Cluso's SixBladeProp

Blades 1 & 4

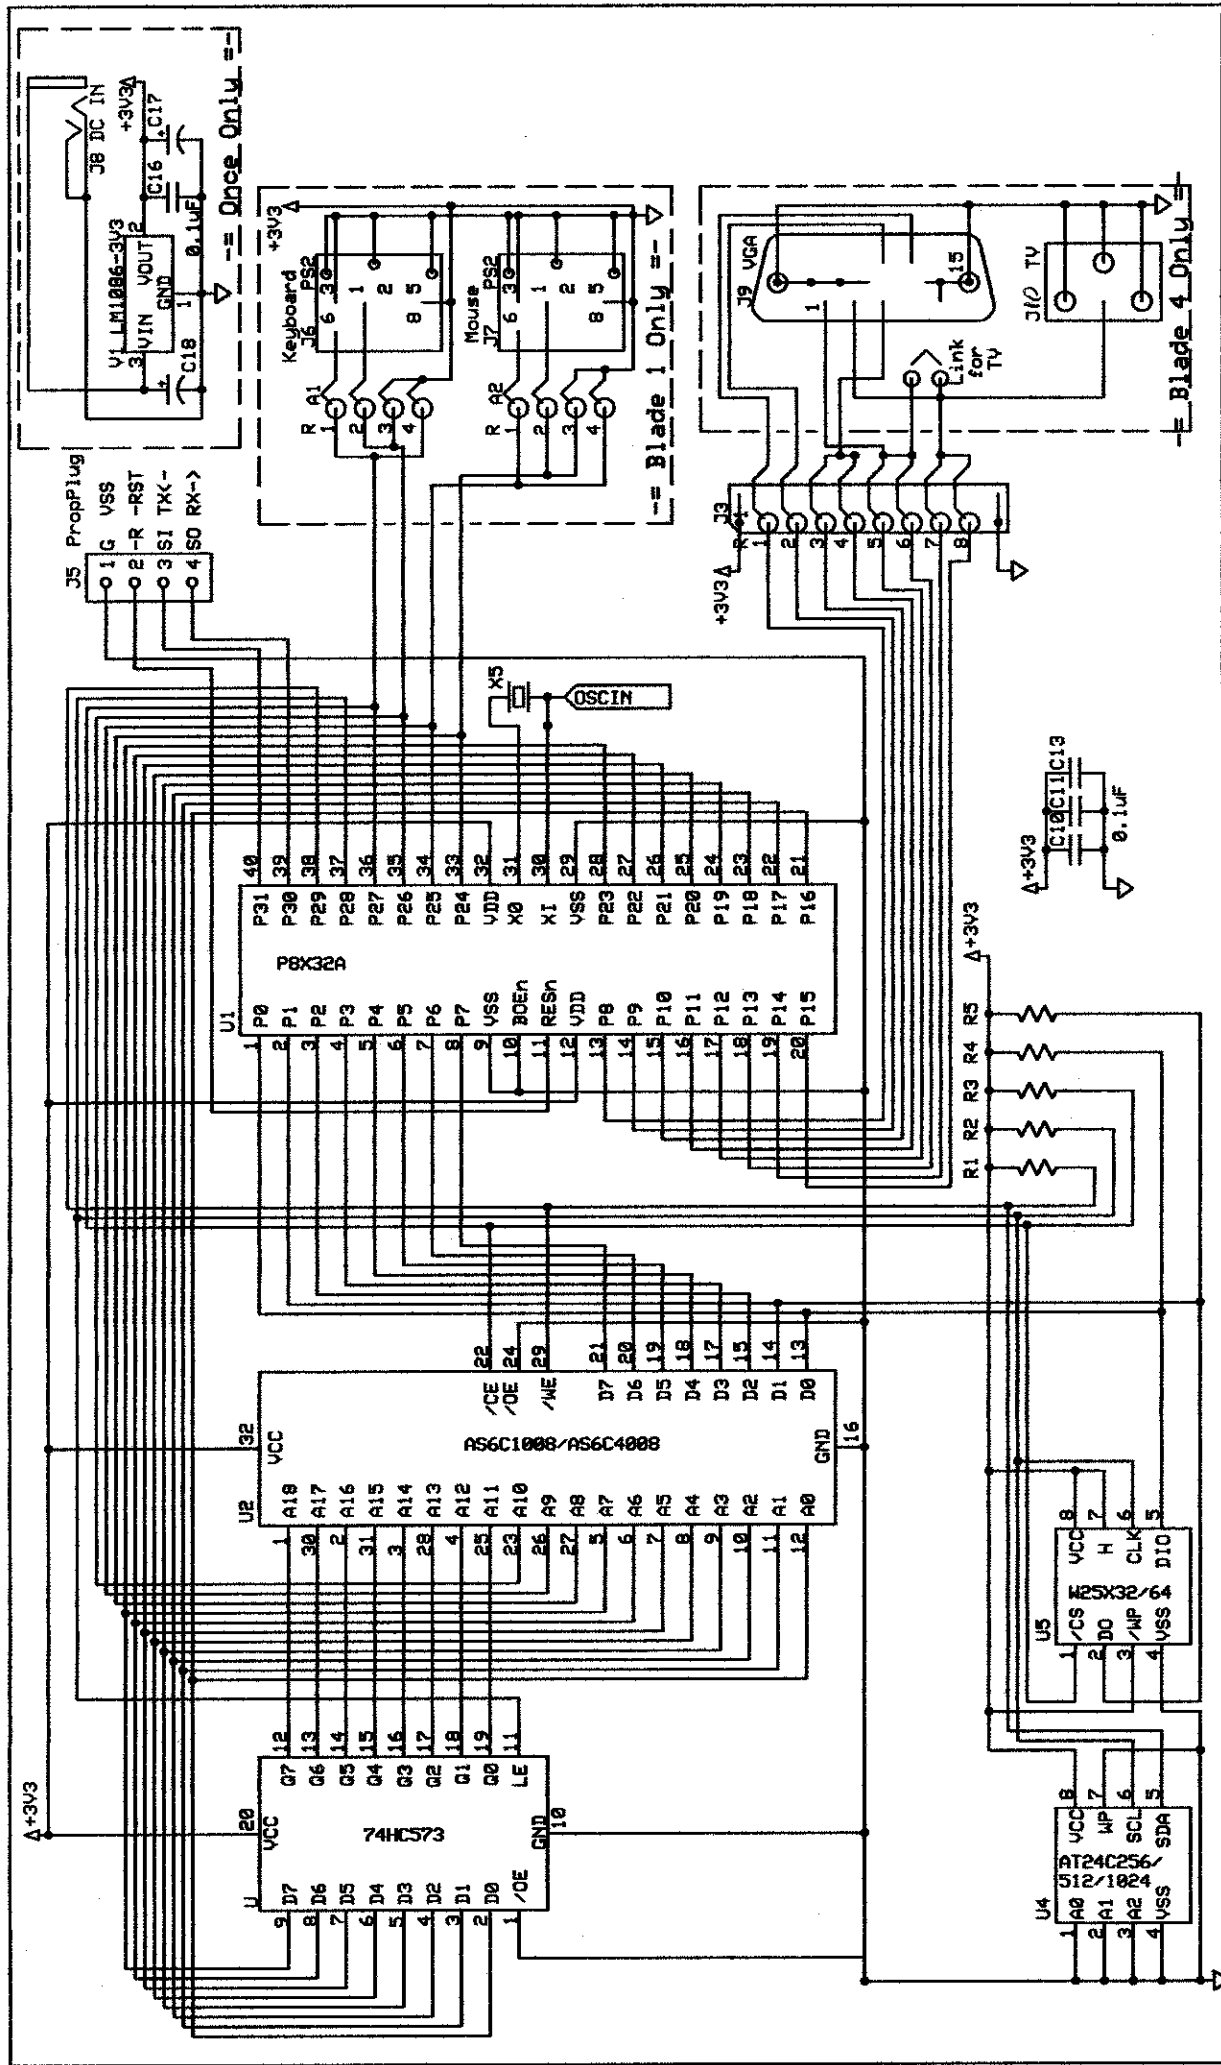
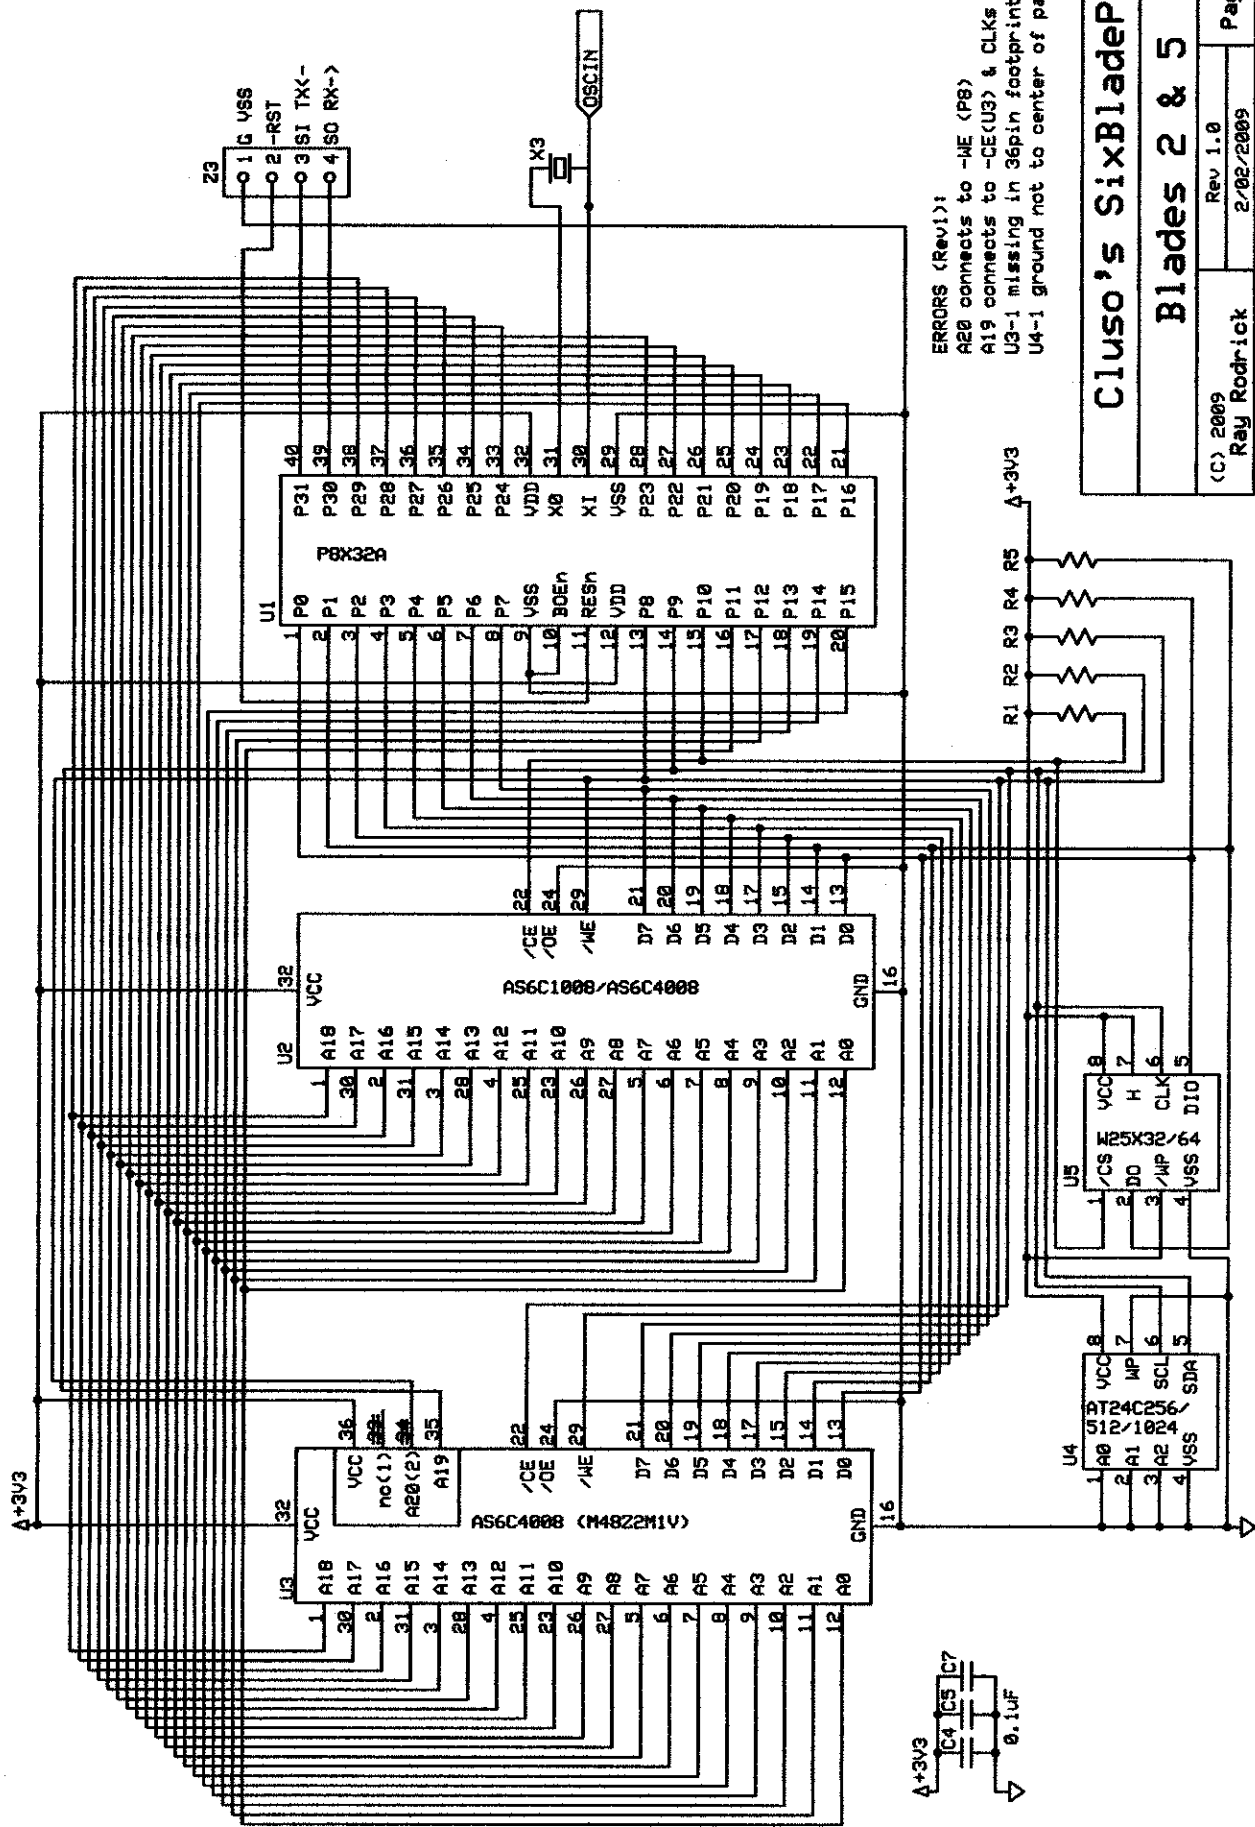
ERRORS (Rev1):
 A20 connects to -WE (P8)
 A19 connects to -CE(U3) & CLKs (P9)
 U3-1 missing in 36pin footprint
 U4-1 ground not to center of pad
